# RENESAS TECHNICAL UPDATE

Product Category	MPU/MCU	Document No.	TN-RX*-A0218A/E	Rev.	1.00
Title	Errata to User's Manual: Hardware for the RX66T and RX72T Groups Regarding the Example of a USB External Connection Circuit		Information Category	Technical Notification	
Applicable Product	RX66T Group, RX72T Group	Lot No.	Reference Document	RX66T Group User's Manual: Hardware Rev.1.10 (R01UH0749EJ0110) RX72T Group User's Manual: Hardware Rev.1.00 (R01UH0803EJ0100)	
		All

This document describes a correction to the “USB 2.0 FS Host/Function Module (USBb)” chapter in the User's Manual: Hardware for the applicable products.

Figure 31.3 **Functional Connection of USB Connector in Self-Powered State**

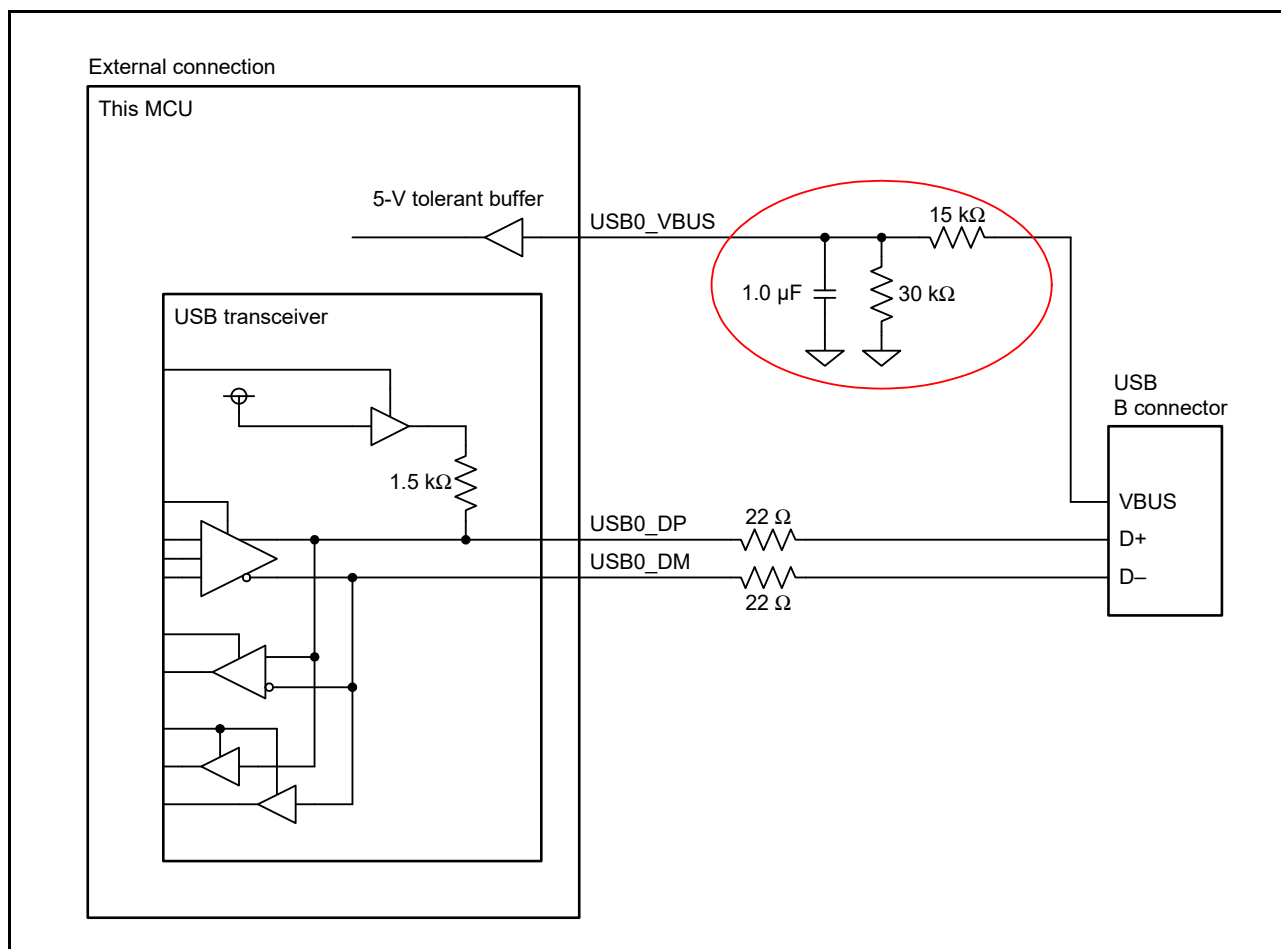
Figure 31.3, Functional Connection of USB Connector in Self-Powered State is corrected as follows.

Use of the circuit shown before the correction will not cause any problems if it is under the condition  $VCC = 3.3\text{ V}$ .
